# Engineering Instruction

No. MD / 384  
ISSUE 2

**TITLE** REPLACEMENT OF LOOSE RIVETS, GEARBOX REAR MOUNTING BRACKETS AND TRIMMERS, CLASS 108 DMU

FIGURE 1

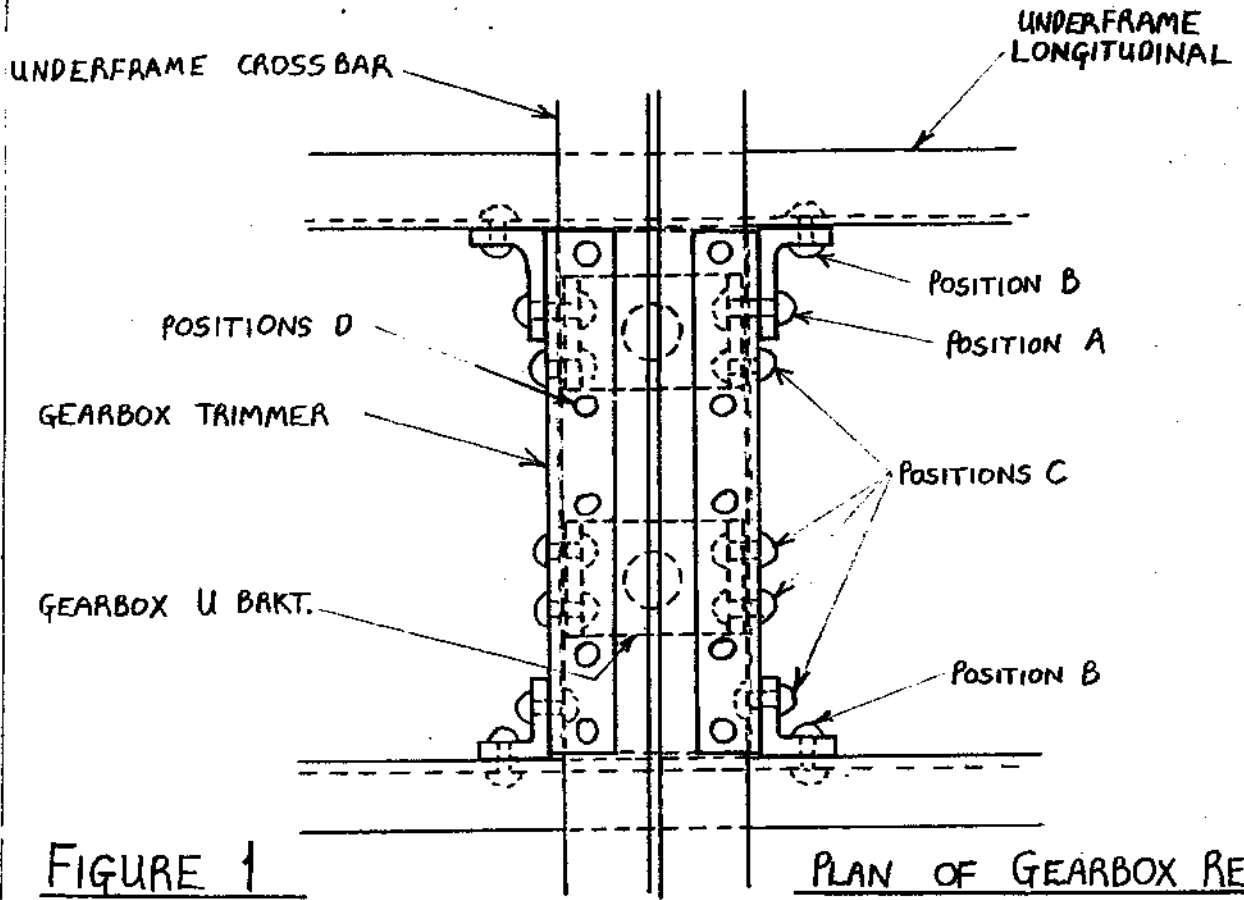
Where rivets fastening the gearbox rear mounting brackets to the mounting trimmer and the trimmer to the underframe longitudinals are found to be loose they are to be replaced as follows:-

In Depots : loose rivets to be removed and replaced by high tensile steel bolts, prevailing-torque nuts, and plain washer. (See Table)

In Main Works : Joints to be examined for signs of movement and to be hammer tested to check for looseness. Joints showing evidence of movement, or having loose rivets, or having high tensile bolts and prevailing torque nuts fitted by Depots as above, to be completely disassembled, cleaned, and refastened using either rivets, or Huckbolts, or Avdeloks (See Table). In positions where there is inadequate access to fit rivets, or Huckbolts, or Avdeloks, then high tensile bolts and prevailing torque nuts may be fitted.

To prevent intermetallic corrosion occurring between the steel bolt or rivet and the aluminium underframe members, the contacting surfaces should be painted before fastening.
